## STAFF REPORT

**TO:** City Council  
**FROM:** Ben Prchal, City Planner  
**AGENDA ITEM:** Conditional Use Permit Amendment for Cedar Pet Clinic – 11051 Stillwater Blvd.  
**REVIEWED BY:** Ben Prchal, City Planner

Re: Cedar Pet Clinic: 11051 Stillwater Boulevard  
Engineering Site Plan Review

**To:** Ben Prchal, City of Lake Elmo Planner  
**From:** Lucius Jonett, Wenck Landscape Architect  
**Date:** October 12, 2018  
**Subject:** City of Lake Elmo Landscape Plan Review  
Cedar Pet Clinic Conditional Use Permit Amendment, Review #1

**1 LANDSCAPE PLAN**  
SCALE: 1" = 20'

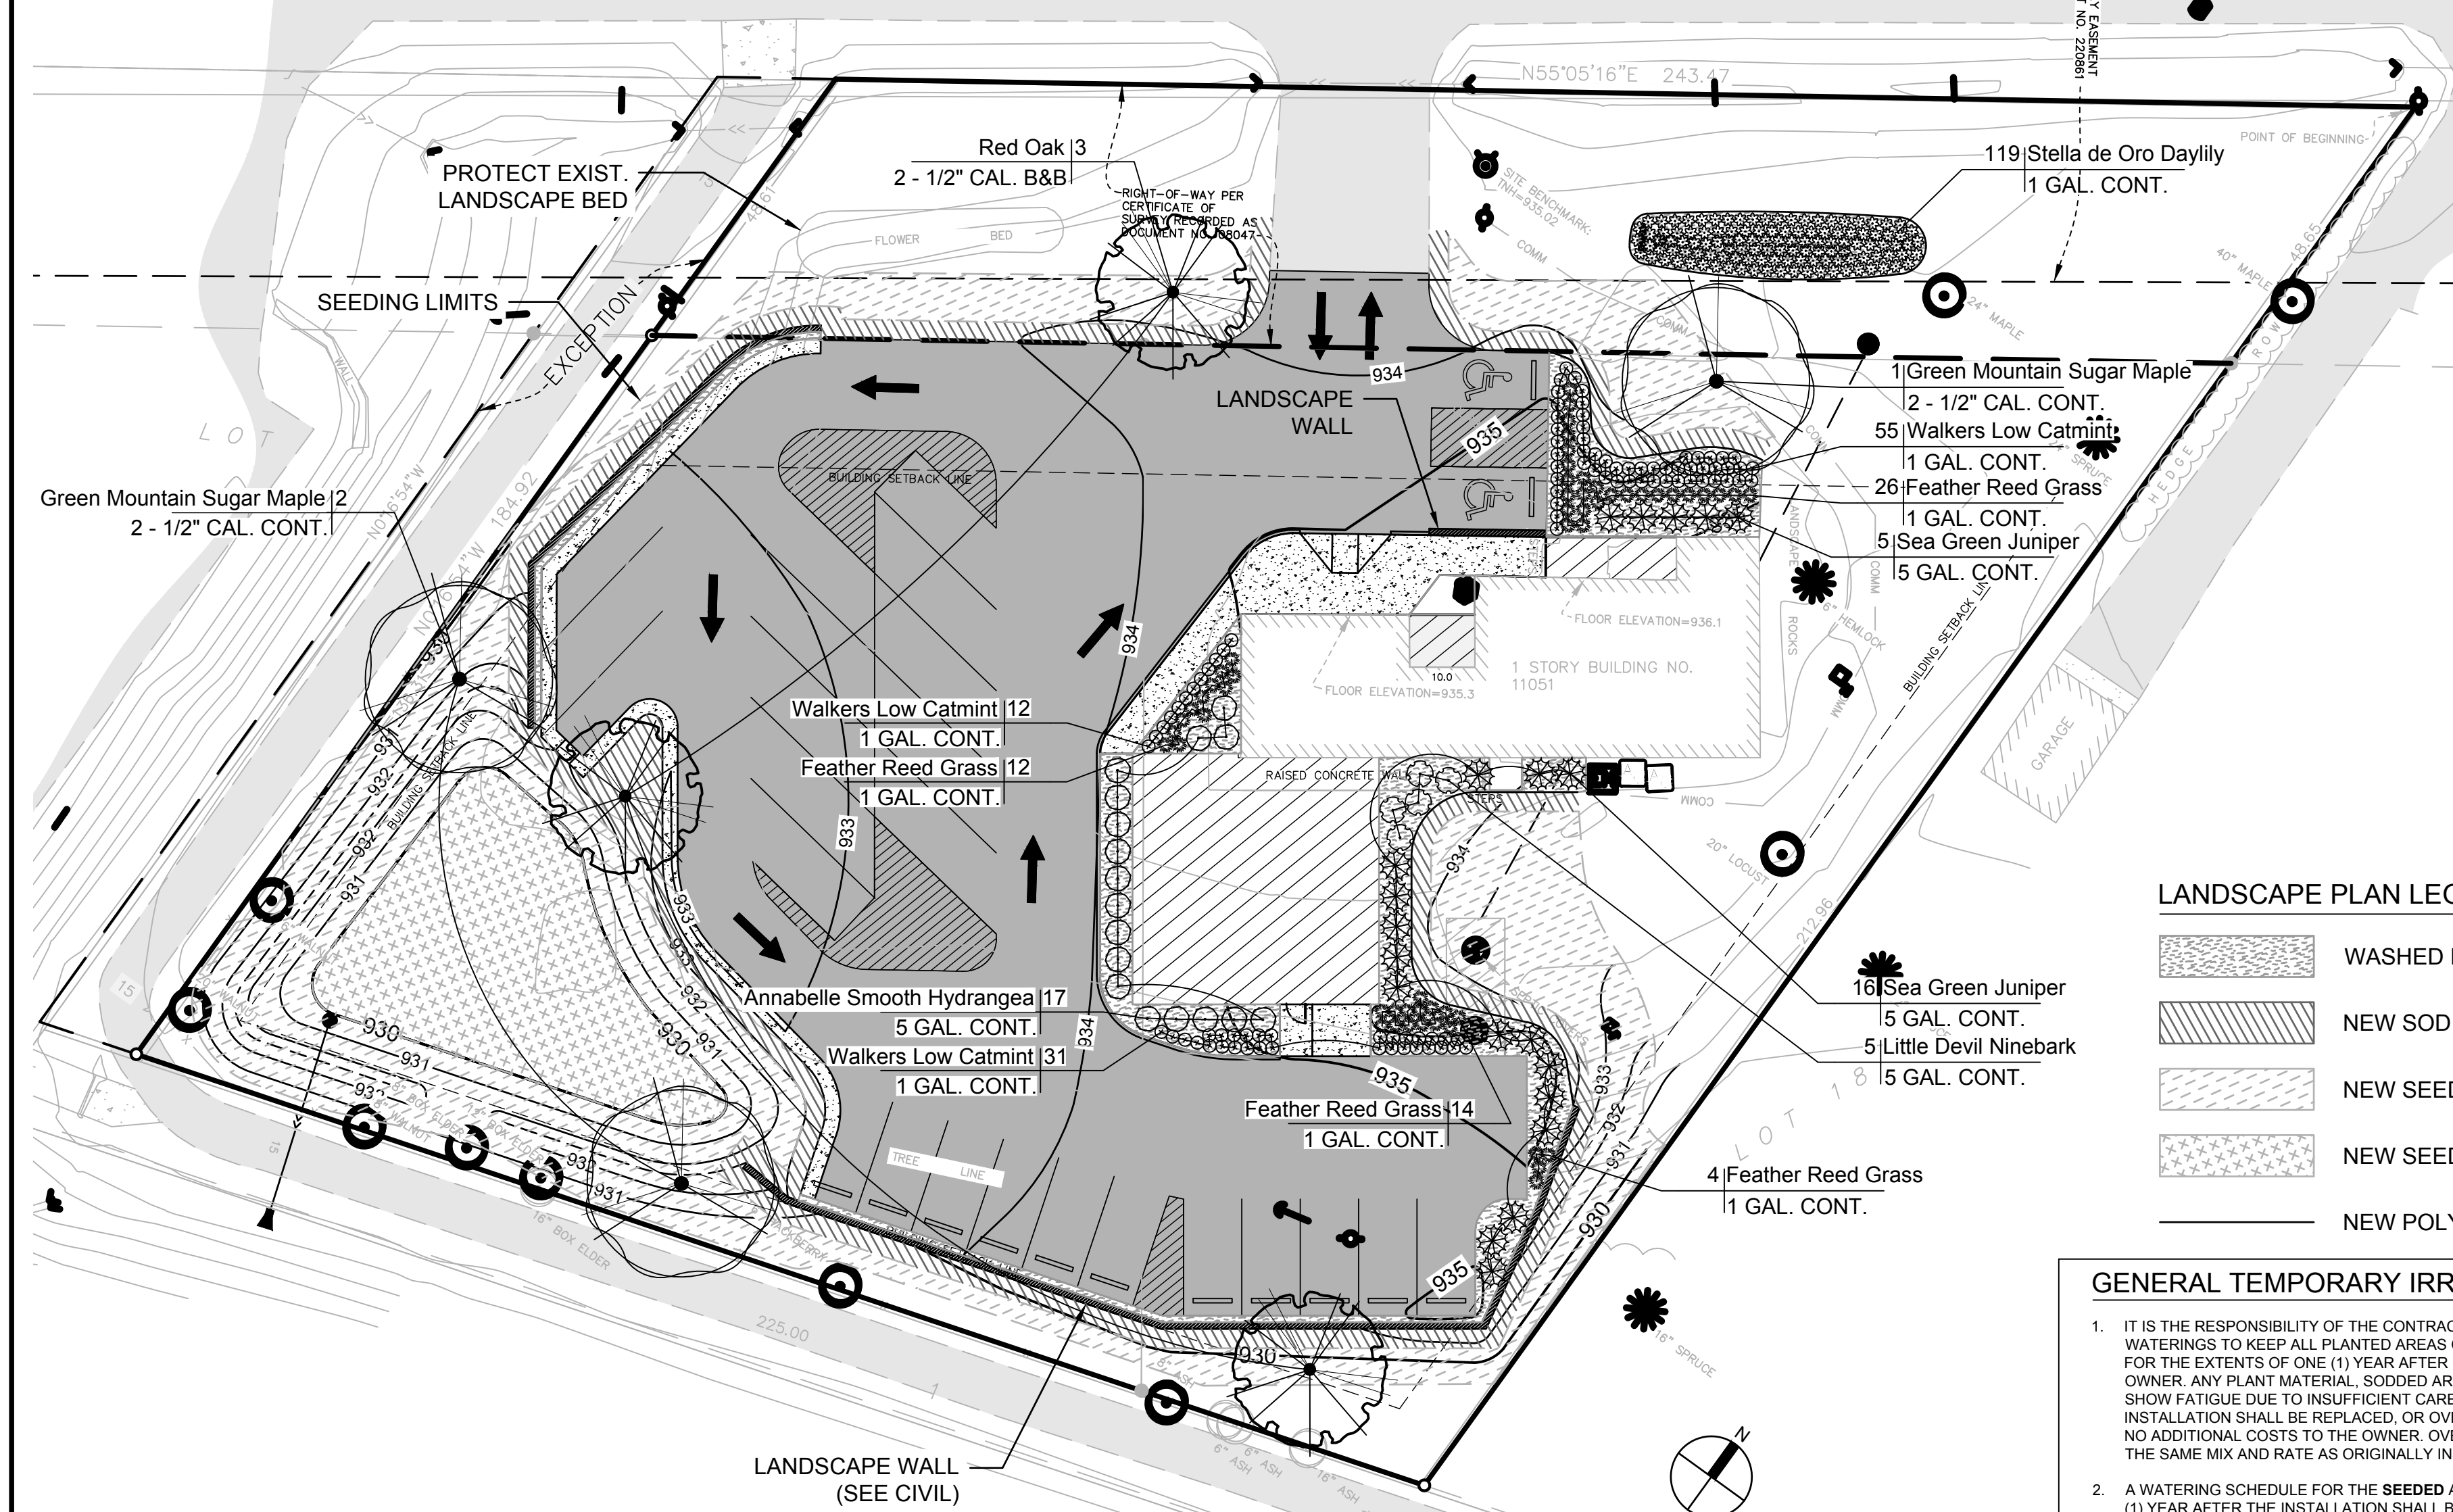
The provided landscape plan does not meet the code required number of trees. The proposed phase 1 plans show more than the code required tree quantities.

- A. A landscape plan has been submitted that does not include all requirement:.
1. The landscape plan does not include required City standard notes and details.
  2. All utilizes and pavements are not shown on the landscape plan to review for tree placement conflicts.

3. Provide the required 13 coniferous trees, that are 6' tall or greater, for mitigation in the landscape plan.
4. In addition to the 13 required coniferous trees, at least 5 deciduous trees are required to meet the 25% coniferous and 25% deciduous tree minimum composition.

5. Landscape plan needs to be updated to show utilities and to include City standard notes and details.

**1 NORTH ELEVATION**  
1/4" = 1'-0"

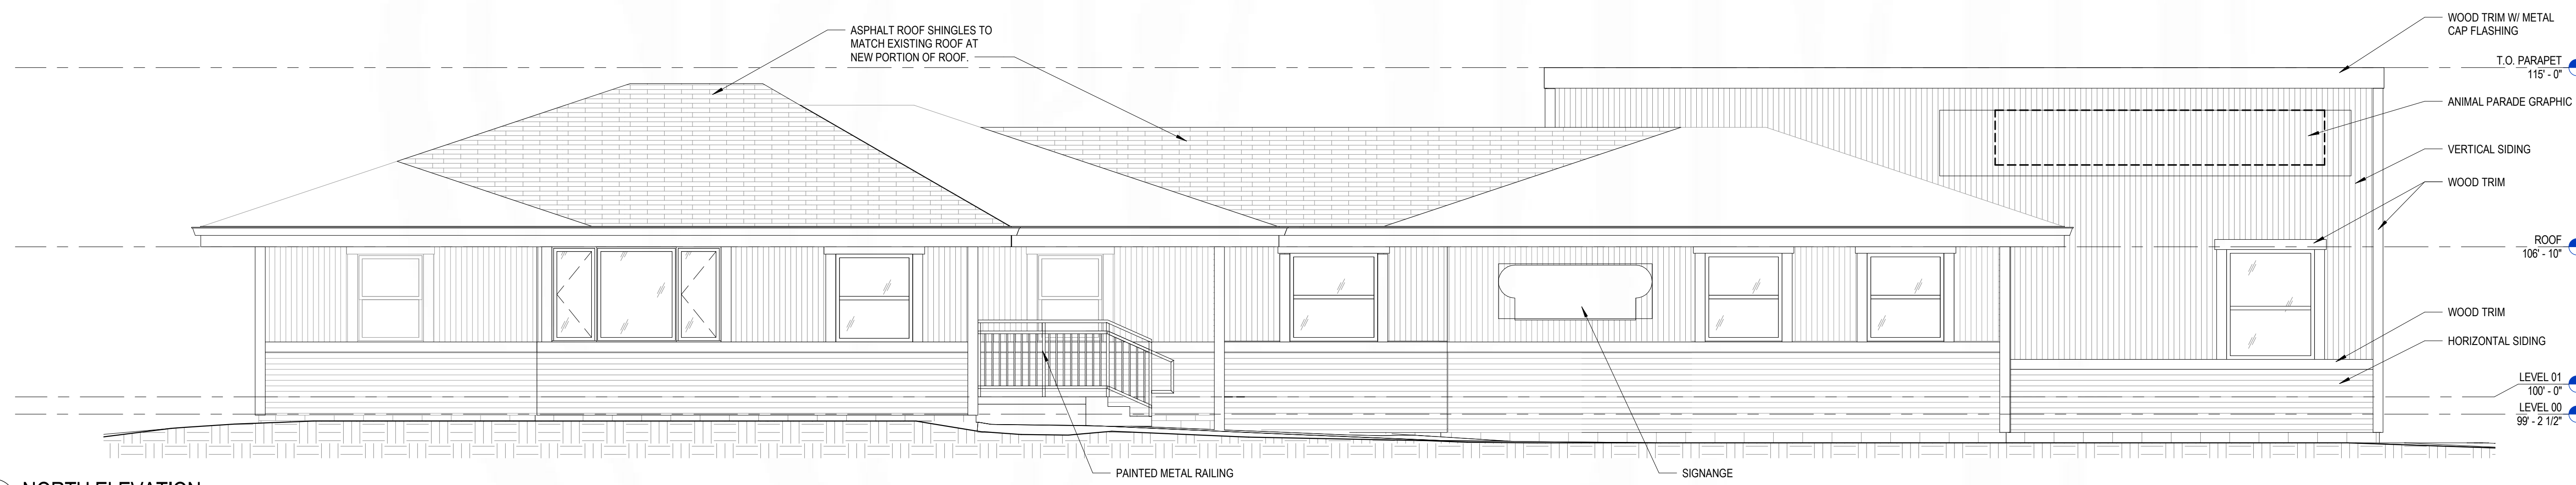
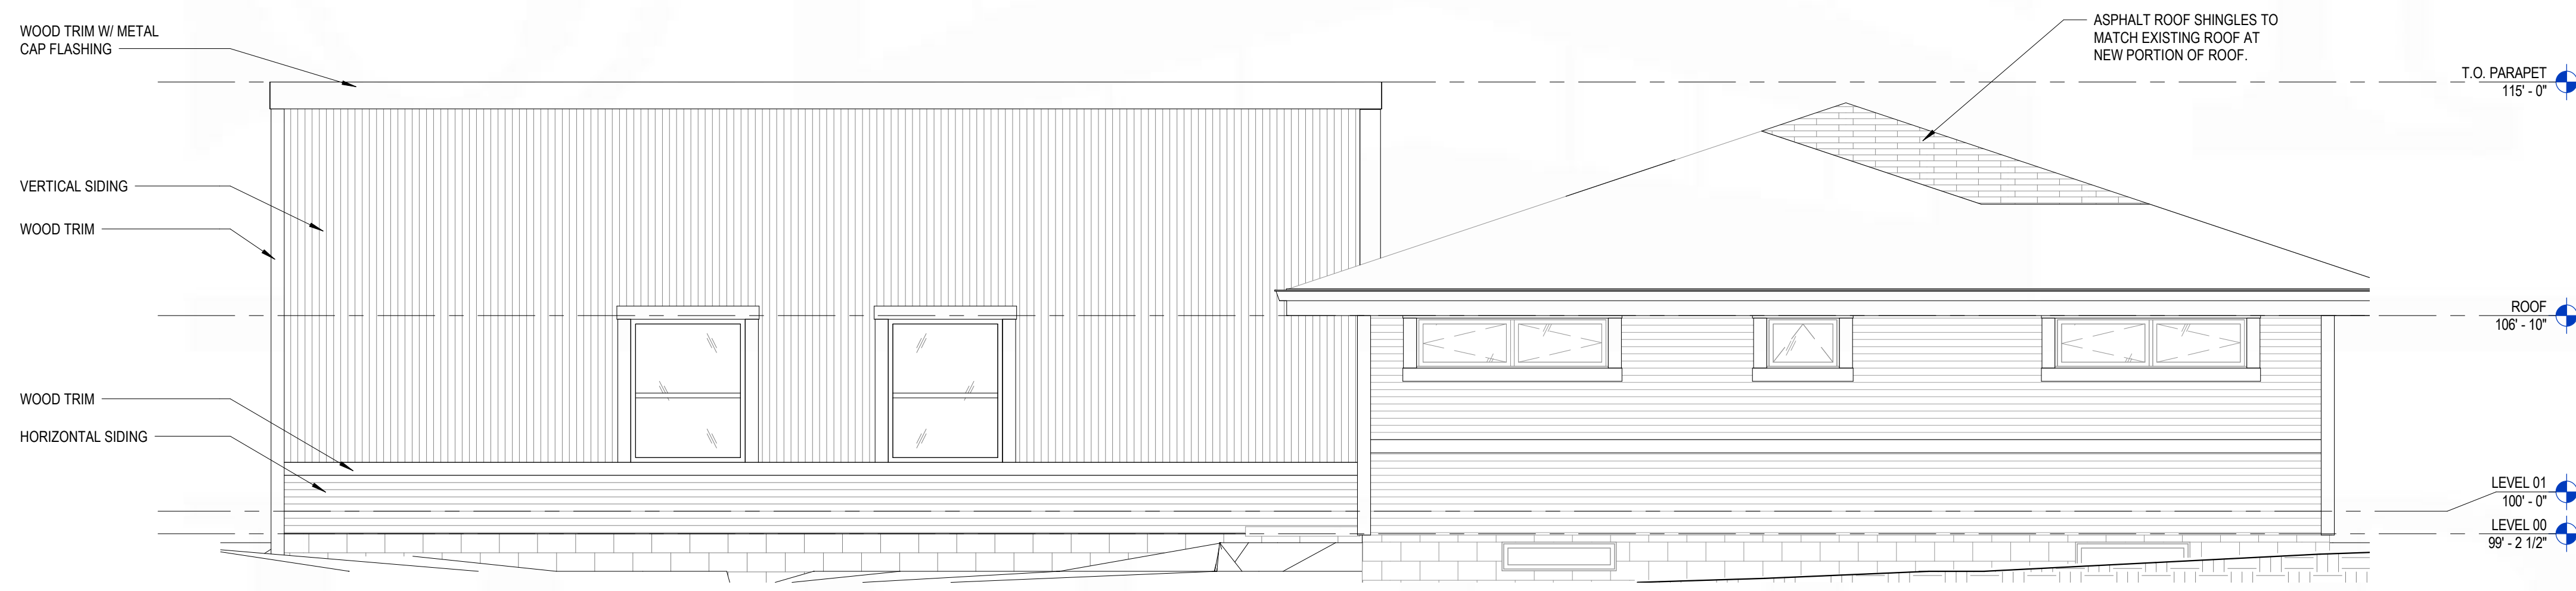
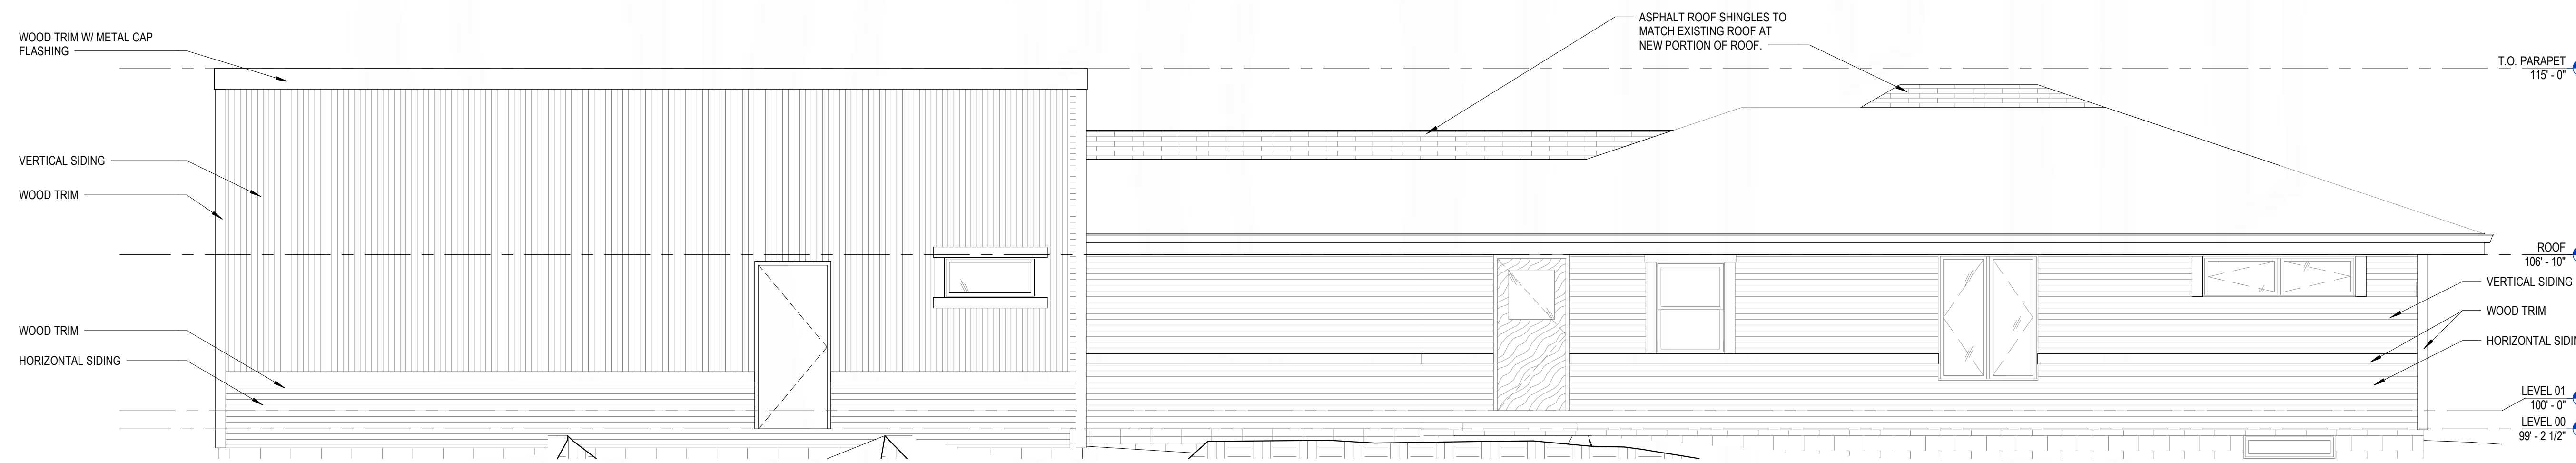
- *Façade* – Blank facades are discouraged and varying roof heights are encouraged to provide architectural detail. After reviewing the architectural plans staff feels that the design meets the expectations of the building design section(s).

- *Lighting* – The design standards manual requires lighting to be provided for entryways, parking areas, pedestrian ways, etc. The plans do not indicate that lighting has been provided.
